UNITED STATES PATENT AND TRADEMARK OFFICE

Office Action Summary	Application No. 10/564,547	Applicant(s) SCHIFRINE ET AL.	
	Examiner ELANA B. FISHER	Art Unit 3733

DETAILED ACTION

Claims 19 and 22:

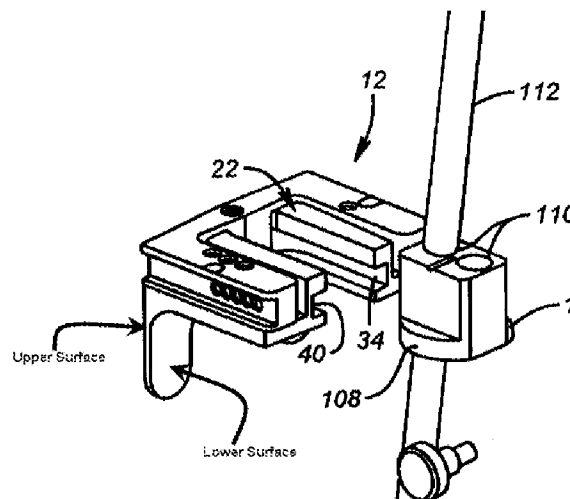
Burkinshaw et al. disclose a device for positioning a total knee prosthesis, comprising: a medullary rod (112) having a proximal end, the medullary rod configured to be introduced into a femoral medullary canal; a rod base (14) attached to the proximal end of the medullary rod, the rod base having i) a face (bottom of 14; FIG 1) configured to contact the femoral condyles when the medullary rod is disposed within the femoral medullary canal, and ii) a base mounting element (106, 108); a tibial plate (26) having a lowermost surface (see diagram provided) configured to be supported on an upper surface of a tibial cut; and a displacement element (28) comprising a distal end extending from the tibial plate and being attachable to the base mounting element such that the medullary rod (112) is approximately parallel to the upper surface (see diagram provided) of the

tibial plate, wherein the displacement element (28) is operable to displace the tibial plate (26) and the upper surface of the tibia with respect to the rod base (14).

The displacement element (28) comprises a slide housing (12) extending from the upper surface of the tibial plate (26) and a slide (34, 40) displaceable on the slide housing. The rod base (14) mounts to the slide (34, 40), and the rod base (14) when mounted on the slide is positioned approximately perpendicular with the upper surface of the tibial plate (FIG 1).
